# DYER WHARF I-195 DESIGN PRESENTATION

2.2.2026

**CV Properties** LLC  
DEVELOPMENT + INVESTMENT + MANAGEMENT

# WAIVER 1 LONG-TERM BICYCLE PARKING

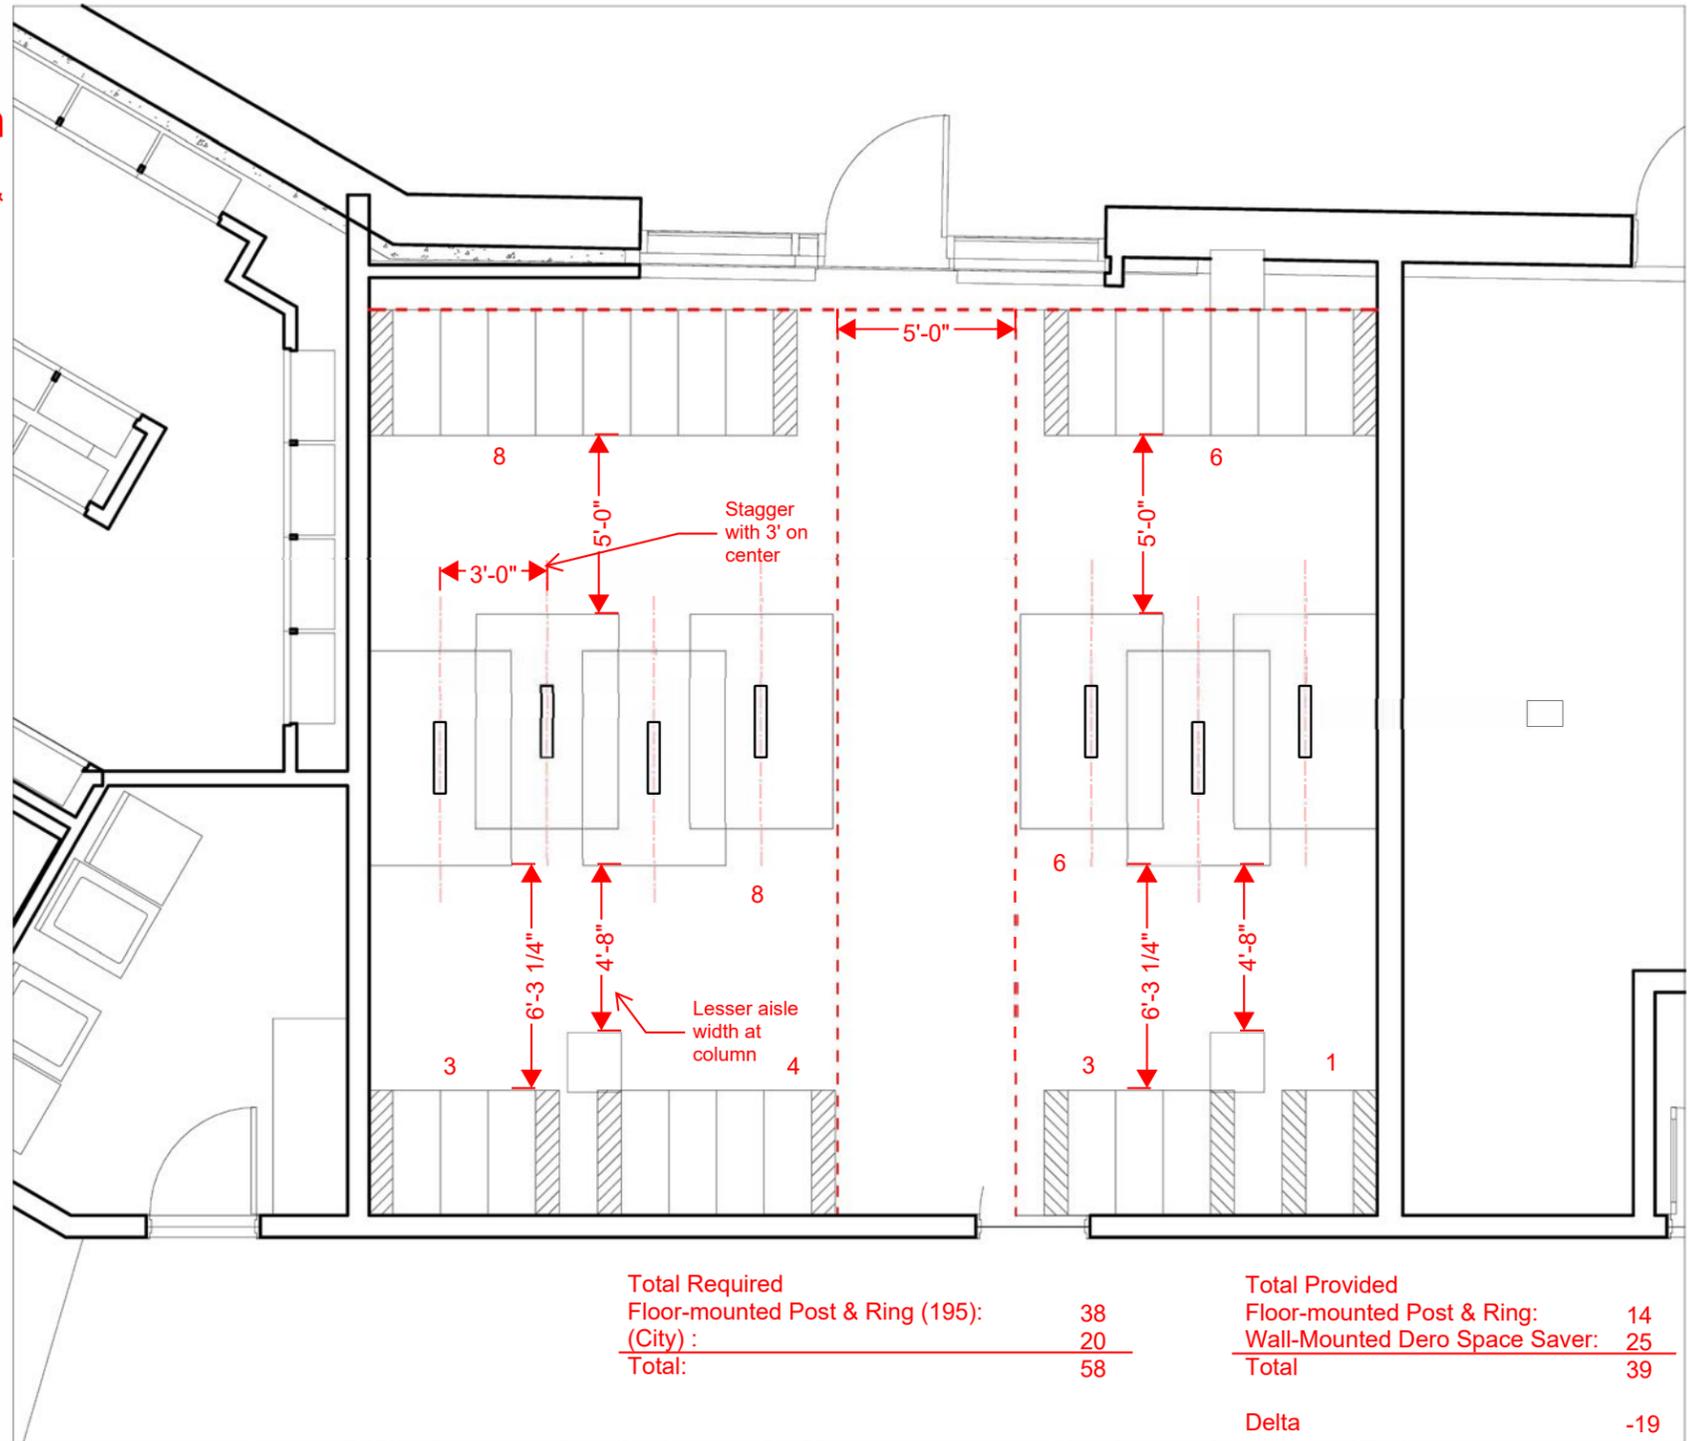
2.4 PARKING & LOADING, SECTION 2.4.D BICYCLE PARKING DESIGN STANDARDS, TABLE 2.4-1 MINIMUM BICYCLE PARKING REQUIREMENTS & DIMENSIONAL STANDARDS 2.4.D.1.A AND 2.4.D.2.C.

A REDUCTION IN THE MINIMUM NUMBER AND AN ALLOWANCE FOR ALTERED DESIGN FOR A LIMITED NUMBER OF THE REQUIRED LONG-TERM BICYCLE PARKING SPACES. SPECIFICALLY, ALLOWING THE DESIGN OF THE BIKE ROOM ATTACHED TO THIS MEMO AS EXHIBIT 1, WHICH USES A MIX OF FLOOR-MOUNTED POST AND RING RACKS AND WALL-MOUNTED RACKS, FOR A TOTAL OF 39 SPACES. BECAUSE THIS IS THE FIRST AND MOST DIMENSIONALLY CONSTRAINED PHASE OF A MULTI-PHASE DEVELOPMENT, WE RECOMMEND THAT THE DEFICIT OF 19 LONG-TERM BICYCLE PARKING SPACES ASSOCIATED WITH THIS DEVELOPMENT BE PROVIDED AS PART OF THE LATER PHASES OF THE DEVELOPMENT AND MADE AVAILABLE TO RESIDENTS OF THIS BUILDING.

# WAIVER 2 SHORT-TERM BICYCLE PARKING

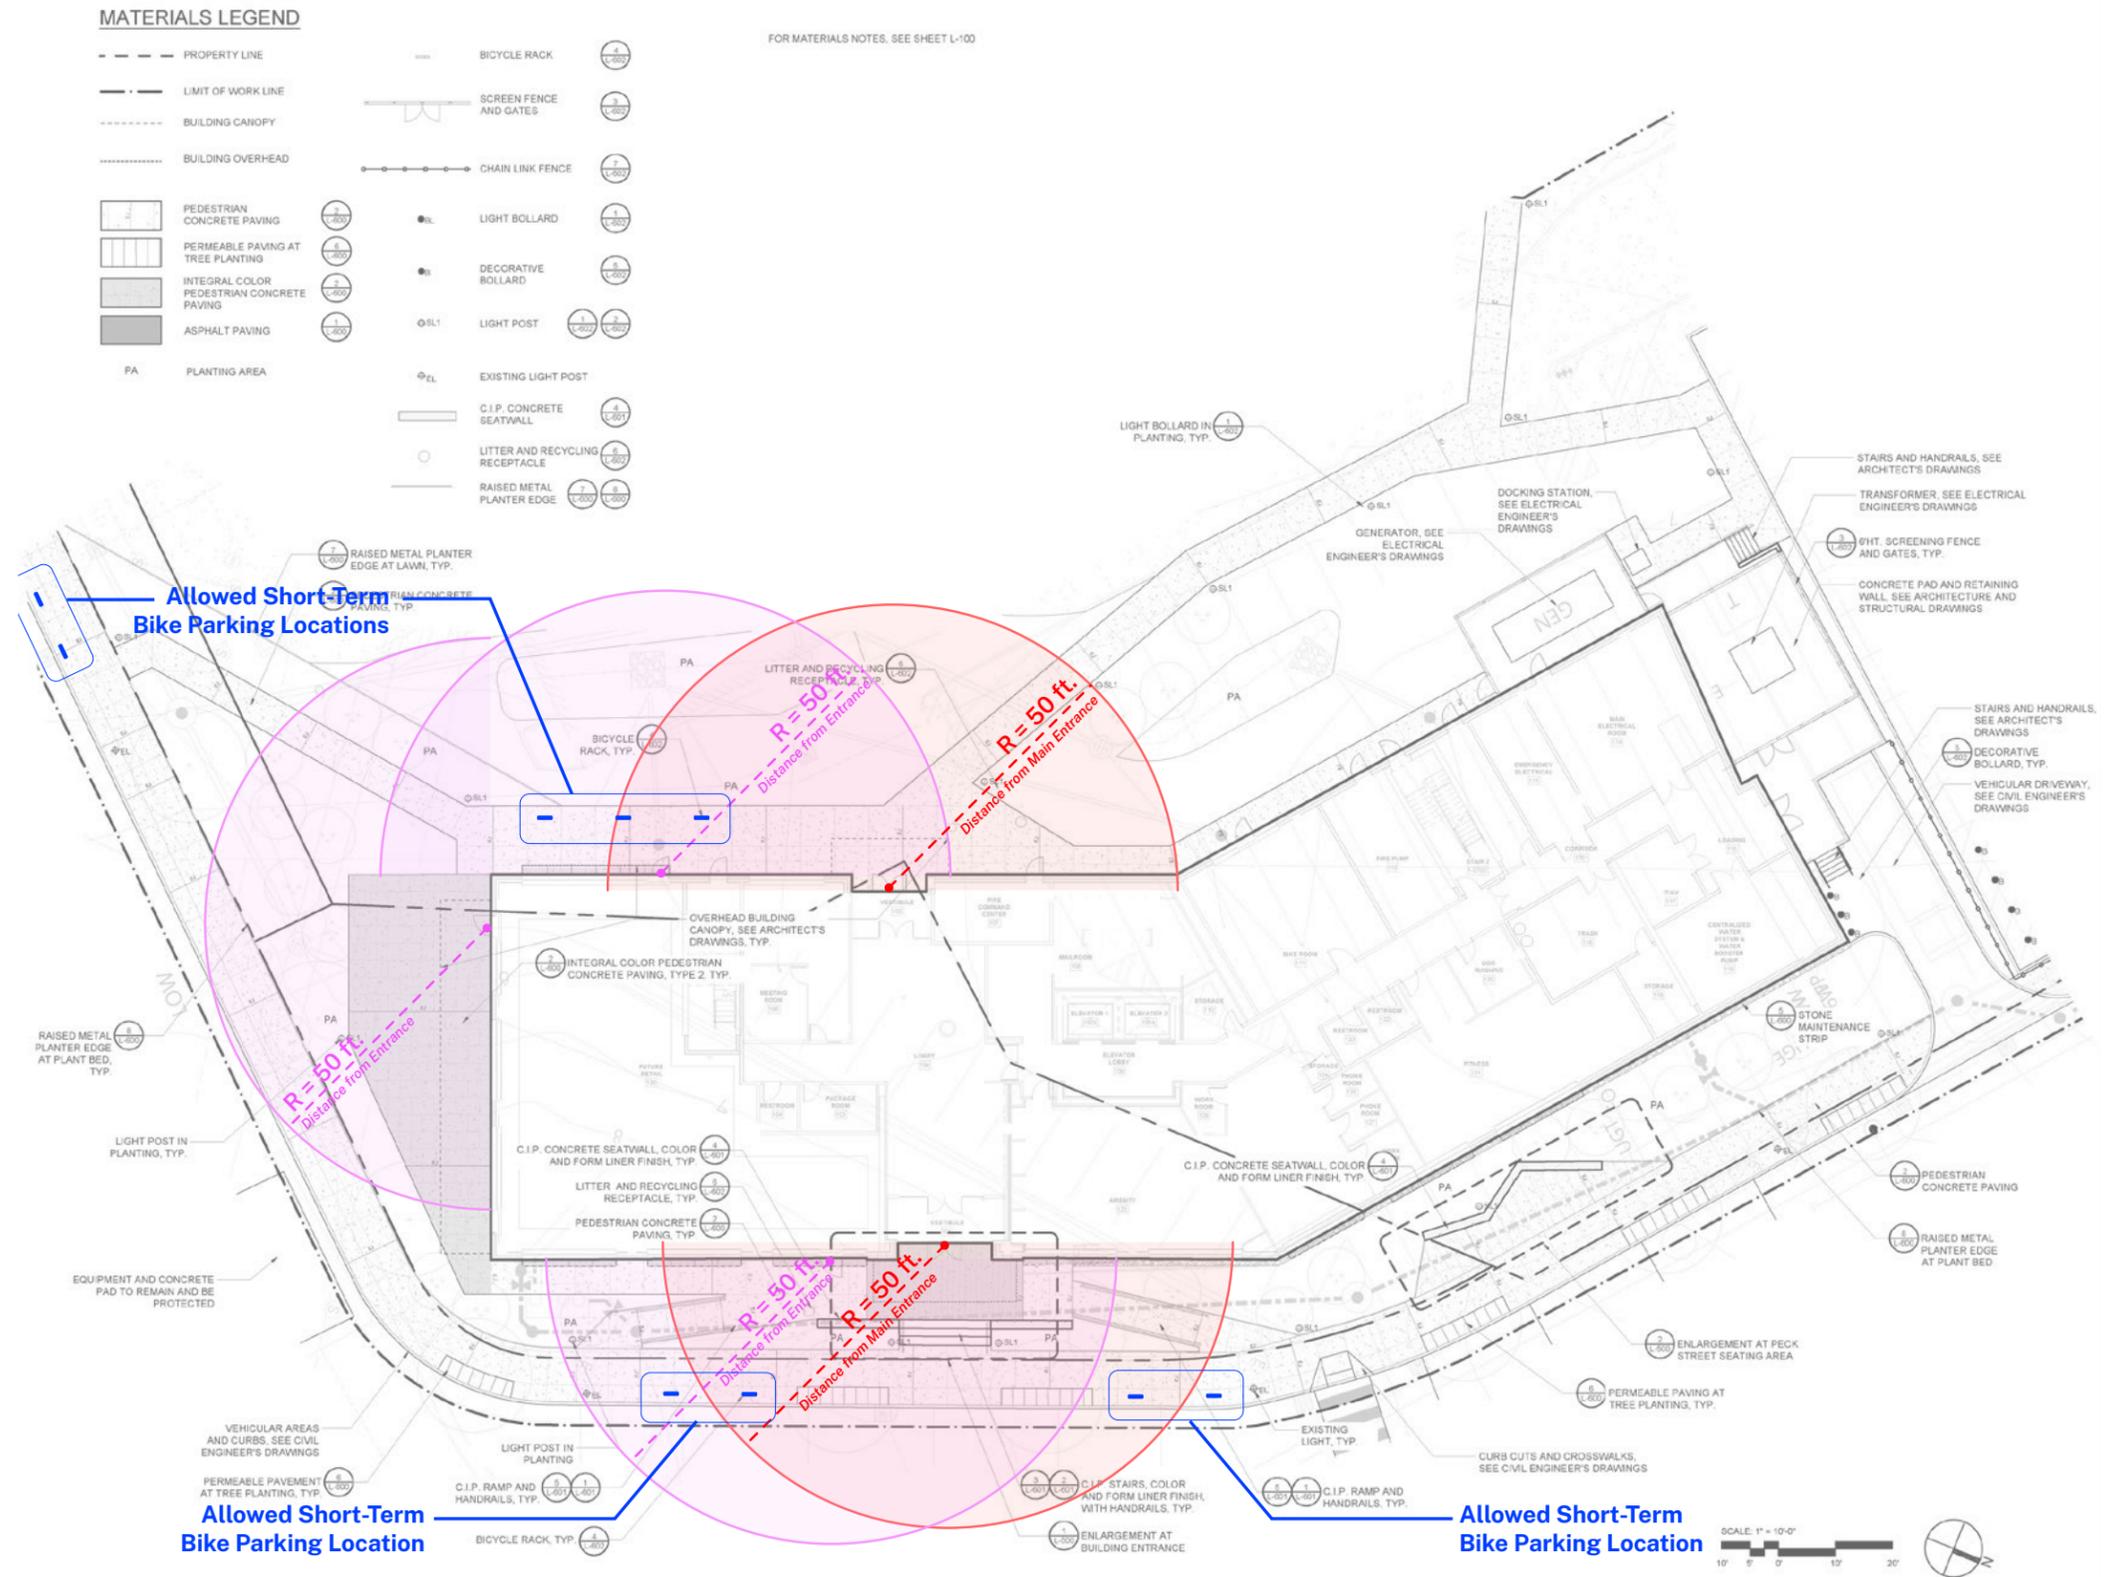
### 2.4 PARKING & LOADING, SECTION 2.4.D.1.B BICYCLE PARKING DESIGN STANDARDS

AN ALLOWANCE FOR THE REQUIRED SHORT-TERM BICYCLE PARKING SPACES TO BE LOCATED MORE THAN 50FT FROM THE PRIMARY ENTRYWAYS TO THE RESIDENTIAL UNITS AND GROUND FLOOR RETAIL SPACE, PROVIDED THE SPACES ARE LOCATED ON THE CLOSEST AVAILABLE LEVEL SIDEWALK OR PLAZA SPACE THAT AVOIDS CONFLICTS WITH CROSSWALKS AND ACCESSIBILITY FEATURES, STREET TREES, ABOVE-GROUND UTILITY FEATURES, AND WALKWAYS FORM SIDEWALK GRADE TO DFE-1. SPECIFICALLY, ALLOWING SHORT-TERM BIKE PARKING SPACES TO BE LOCATED IN THE PLACES INDICATED BY THE DIAGRAM ATTACHED TO THIS MEMO AS EXHIBIT 2.

# WAIVER 4 BLANK WALL, GROUND FLOOR TRANSPARENCY AND ENTRANCE REQUIREMENTS:

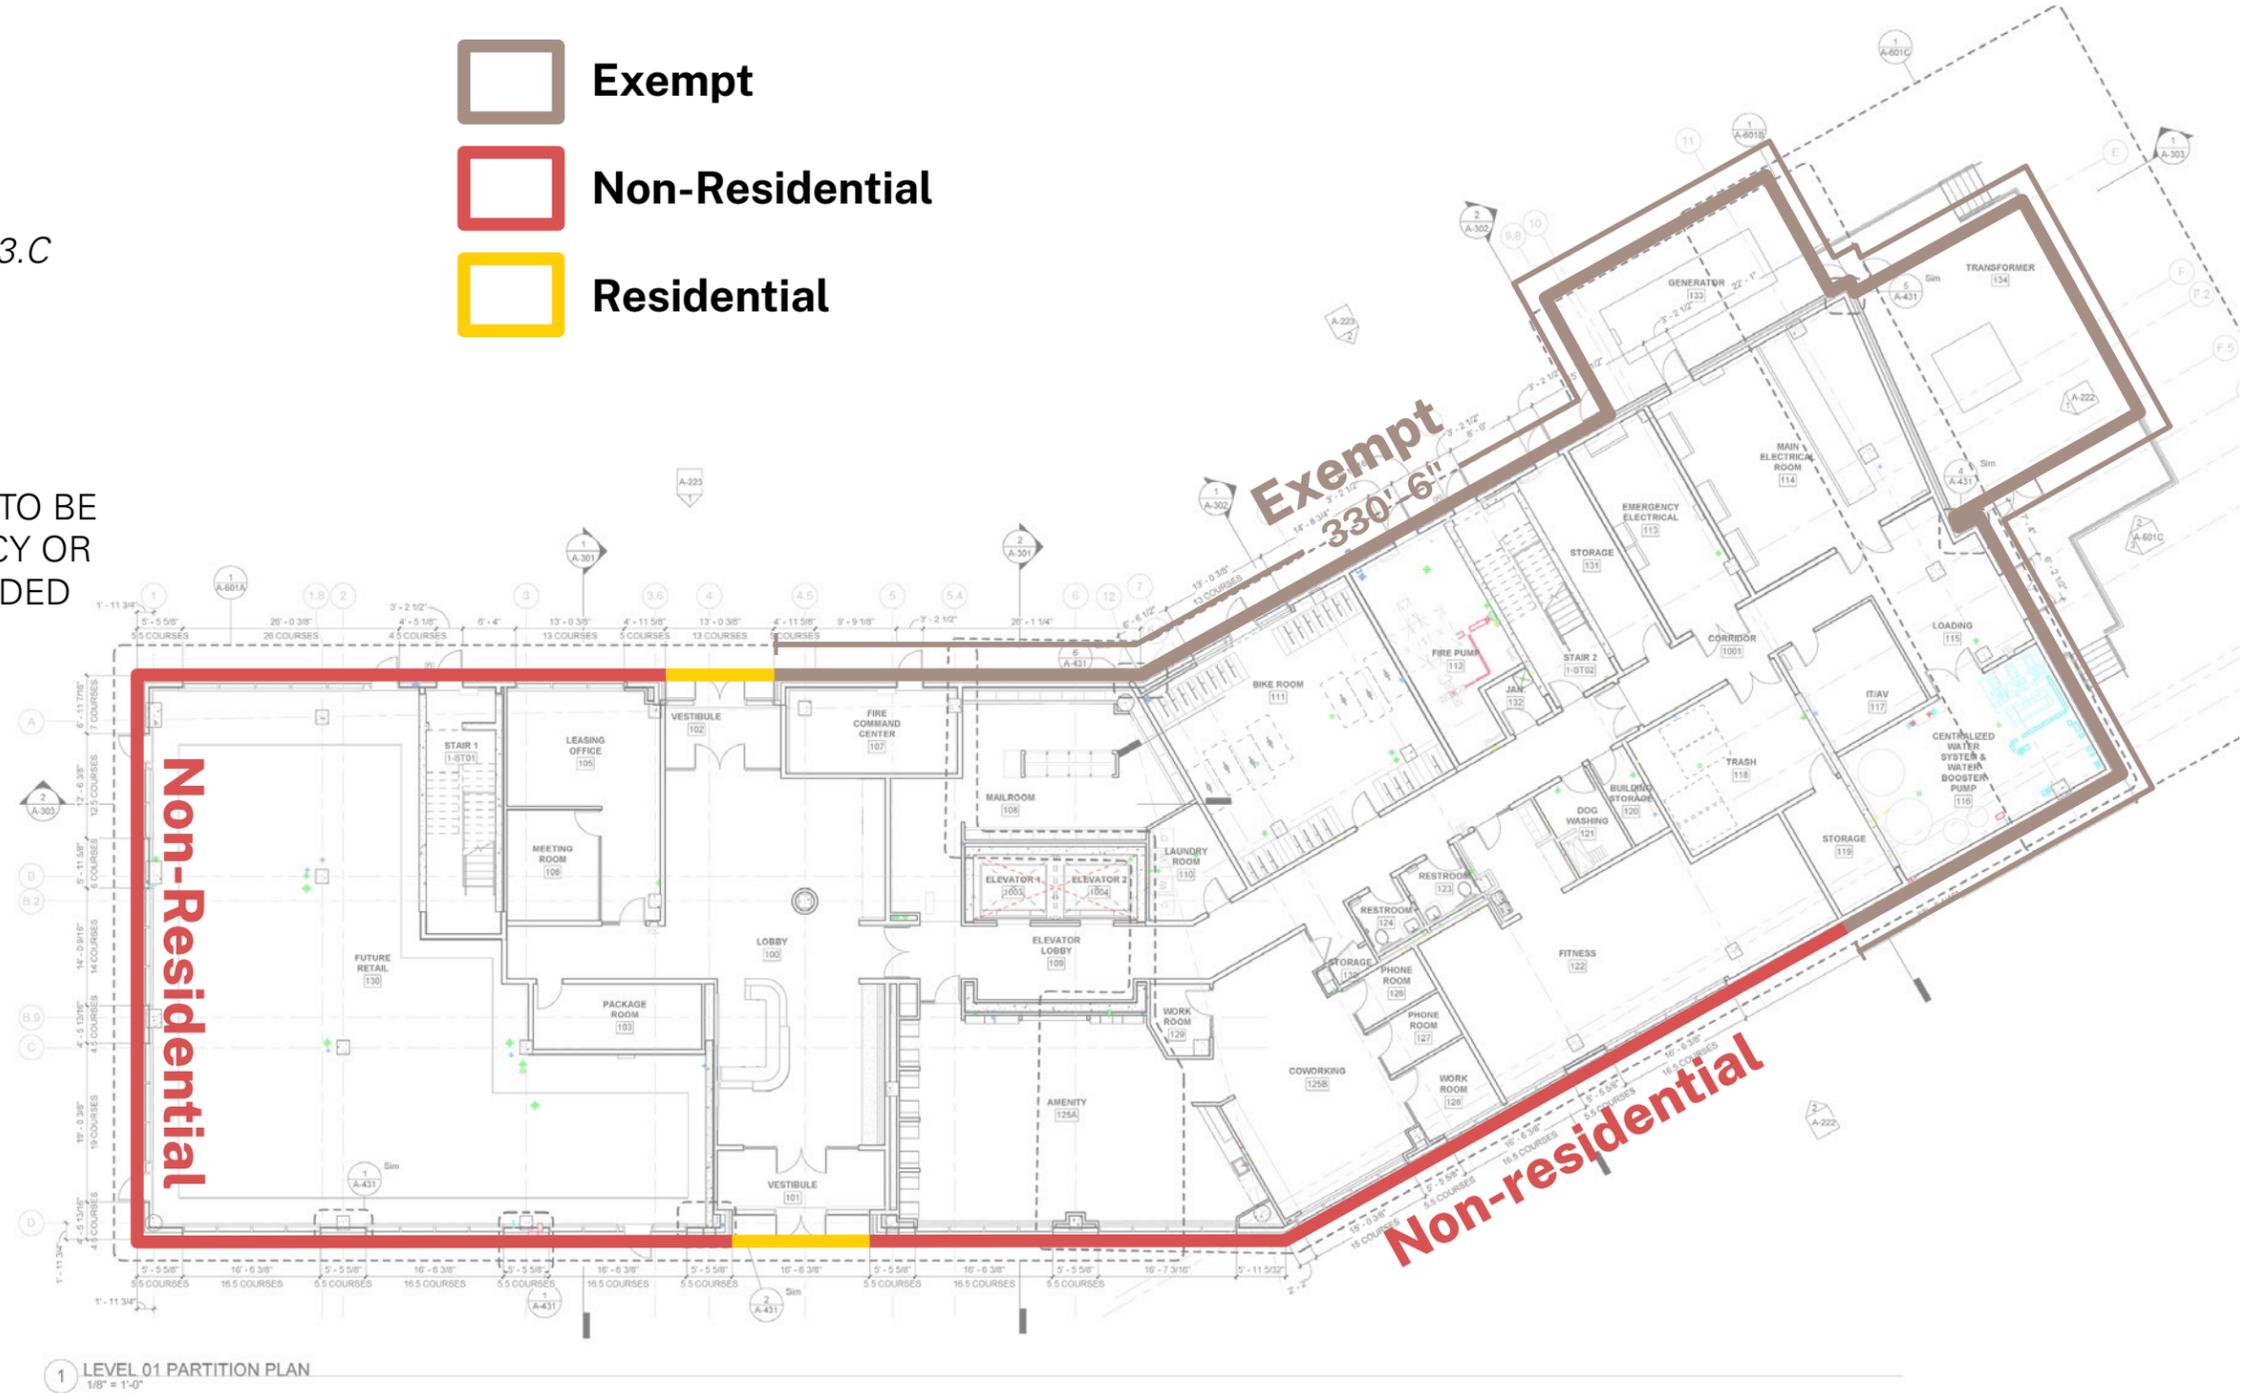
2.5 DESIGN STANDARDS,  
SECTIONS 2.5.A.2.A, 2.5.A.2.B AND 2.5.A.3.C  
(FIGURE 2.5-2)

ALLOW THE AREAS OF THE FACADE ENCLOSING BACK OF HOUSE SPACES AS INDICATED IN THE ATTACHED EXHIBIT 4, MEASURING UP TO 330'-6" LINEAR FEET, TO BE OPAQUE WALLS WITHOUT TRANSPARENCY OR EXTERIOR BUILDING ENTRANCES, PROVIDED THEY ARE SCREENED EFFECTIVELY BY PLANTINGS.
